ANGUS COUNCIL

COMMUNITIES COMMITTEE – 3 MARCH 2015

APPLICATION FOR ROAD CONSTRUCTION CONSENT

This report concerns the consideration of an application for Construction Consent for the extension of an existing public road associated with a flatted development at Church Street, Arbroath.

Figure 78

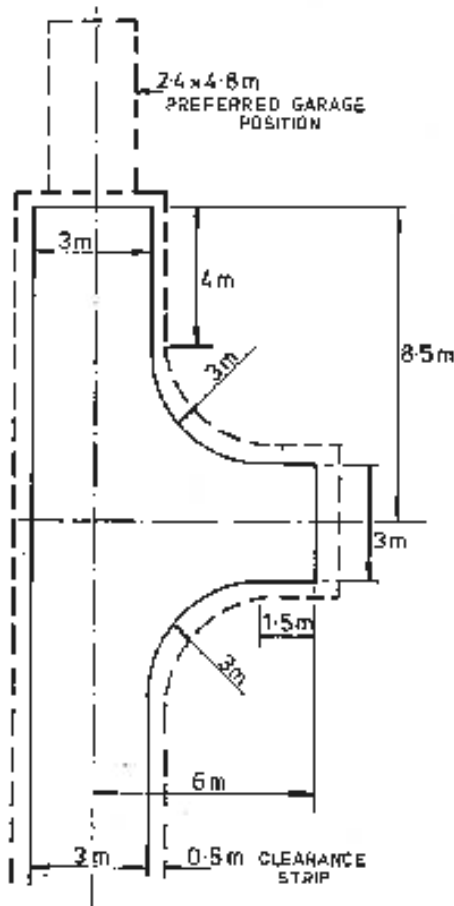
Having viewed the Council policy on parking spaces and turning heads specifically figure 78 for the type of turning head here the standards cannot be met. The design fails to take in account the 3m radius at the access to the turning head, this along with the 500mm clearance strip makes it impossible for the design shown.

There needs to be considerable movement of certainly the middle spaces. Moving North 2m places the space over the access path and into the building. Or at least an additional 3m is needed to widen the area placing the outer spaces well into the neighbouring properties. Further this move cannot allow the centre of the turning head to move more than approx. 0.5m closer to the west and the end of the road or fail the 8.5m requirement.

- 5.6 In consideration of the objections raised, reference had been made to the planning permission previously granted by the Council and the former Angus Council Road Standards which prevailed at that time. These former standards were used by Roads officers in consideration

of the planning application and provide additional, material guidance on the provision of turning heads for cars. This guidance is provided in Figure 78 in **Appendix 3**.

Appendix 4 – Application Drawing No. 3724/WD/09, Revision H

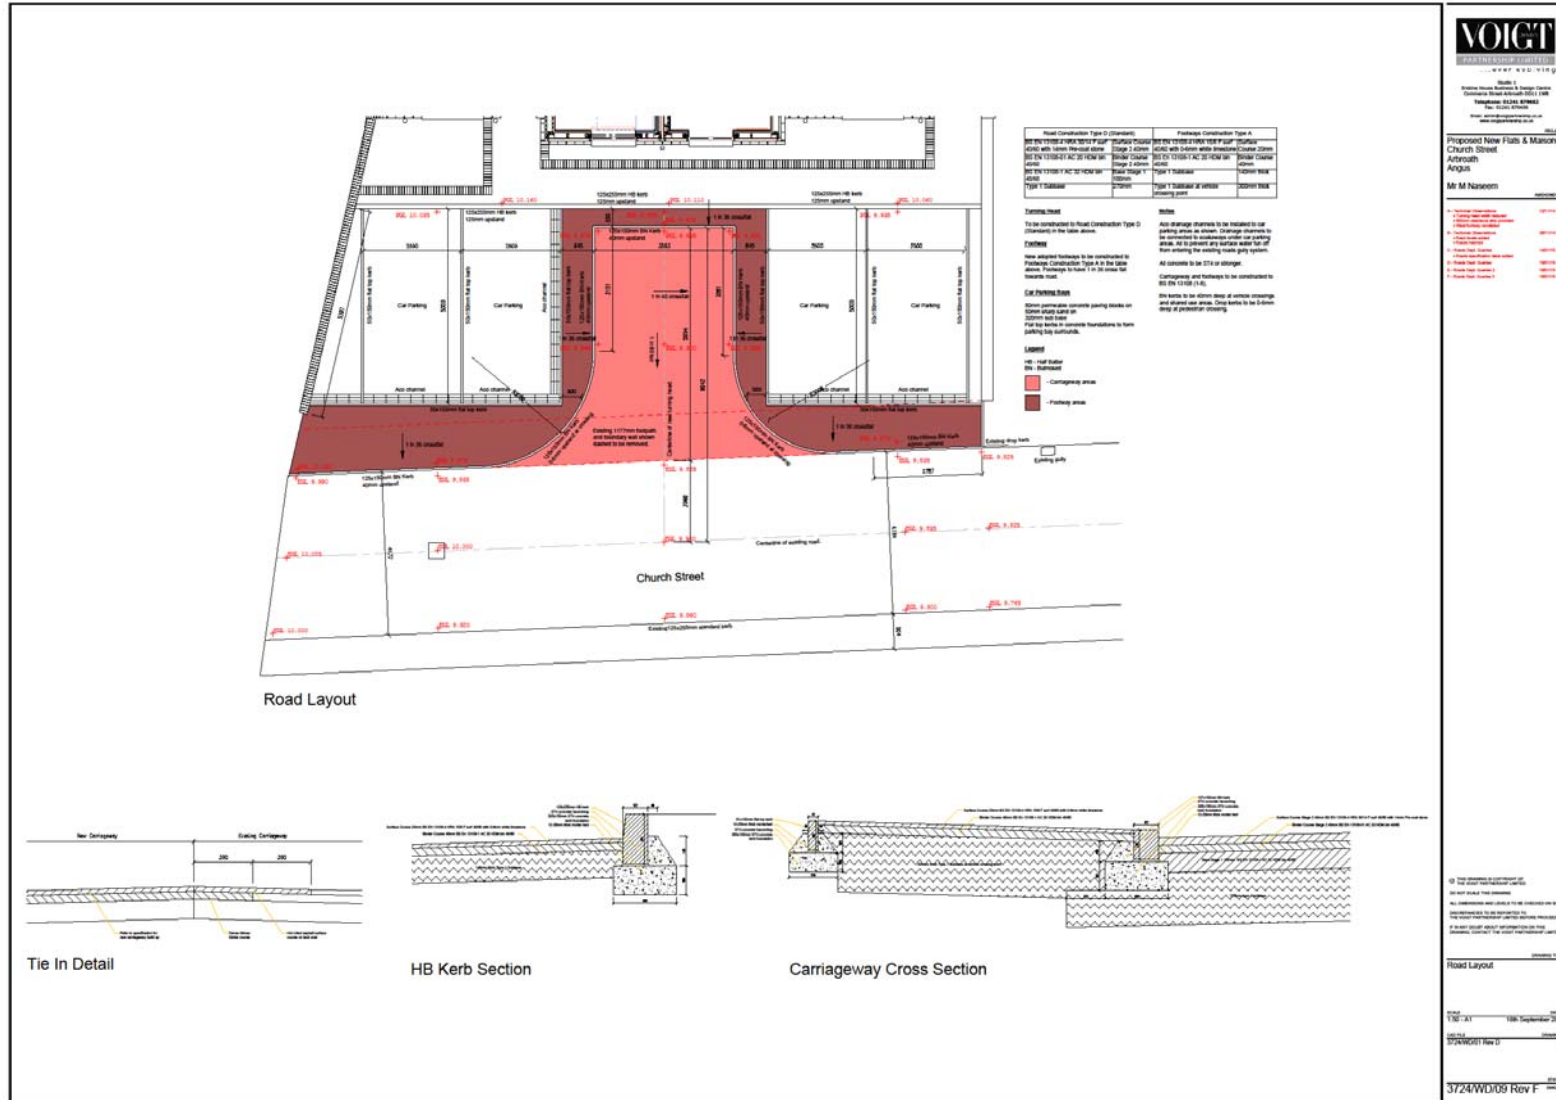
The distance between the southern kerb in Church St and the start of the spaces is extremely narrow. The road is 4.5m wide plus the pavement at 1m then gives manoeuvring distance (aisle) of 5.5m. Further to the east in the street similar parking spaces have an aisle of approx. 6.7m and I have viewed vehicles struggling with this. I understand for a 2.5m space, 6m is the recommended minimum in Fife.

Vehicles can overhand the spaces blocking the sole access to the flats. Bollards would be required. The design leaves no space for possible future issues such as converting a space to disabled parking or electric vehicle charging points. This demonstrates how small the area is.

Having received the revised plans 3724/WD/09 rev F they still fall short of the minimum standards

1. The turning head still doesn't maintain the 500mm clearance strip all the way around. The design fails to meet minimum standards because the site is too small to do so.
2. The first and forth spaces are too narrow at 2.5m. The Roads department has already specified must be 3m wide due to the adjacent walls. The design fails to meet minimum standards because the site is too small to do so.
3. The western most space actually uses part of the pavement. The design fails to meet minimum standards because the site is too small to do so.
4. The spaces are not parallel to the road but angled. This would appear to be in the region of 80 degrees. The design fails to meet minimum standards because the site is too small to do so.
5. The width of the road and dropped pavement is 5.3m at the eastern boundary wall which is far too narrow in my opinion to allow for access.

An updated drawing, reference no. 3724/WD09 Rev H is now available and is attached for your information. The updated drawing differs insignificantly from the previous drawing provided to you (Revision F); the only changes being the addition of further dimensioning lines and drawing scales and widening of the proposed footway adjacent to the easternmost parking bay, in order to ensure that the existing footway width is not reduced. This has resulted in a slight chamfer of the parking bay but with little, material extent – approximately 100mm (4"). The parking bay, at its shortest point, is now proposed to be approximately 4.95m in length. If the upstand to the kerb line at the end of the bays adjacent to the proposed building were to be removed and those kerbs laid flush this could provide a potential increase in the effective length of this bay, to 5.075m or thereby.

1. The turning head has a minimum 500mm overhang strip over its entire length, as shown on both revisions of the drawing.
2. The available parking width to the face of the boundary wall adjacent to the easternmost bay is approximately 2.95m. At its narrowest point, the space available to the face of the proposed wall for the westernmost bay is 2.75m and at the point at which the average car door would be opened, the effective width for parking is 3.25m. Notwithstanding, the 3m bay width is recommended for use in public car parks and such like and not in areas under private ownership. In addition, it should be noted that the width of the turning head, at 3.563m, is actually 563mm in excess of the minimum stated requirement of 3.0m. If the turning head width were to be reduced to the 3m minimum allowed, then, additional space could be created for the parking bays. However, this would have a slight decrease in the effectiveness of the turning head for the public road. Hence, a balance has been struck.

3. At no point does the westernmost space use the part of the footway. On the assumption that you meant to refer to the easternmost space, I have addressed your concern in paragraph 4, above.

4. All four parking bays are perpendicular (90°) to the existing road. Whilst the turning head is 88° to the existing road this is not considered to raise any significant, traffic safety concerns or difficulties in turning for cars.

5. The width between the easternmost bay and the opposite kerb line is 5.3m as you suggest. Whilst this will make it more difficult to access this space than the others it is not considered to be such a significant factor

that would render the whole proposal unacceptable. Vehicle swept paths for an average car have been checked and have shown that access/egress to the bay should be possible, using the full road width.
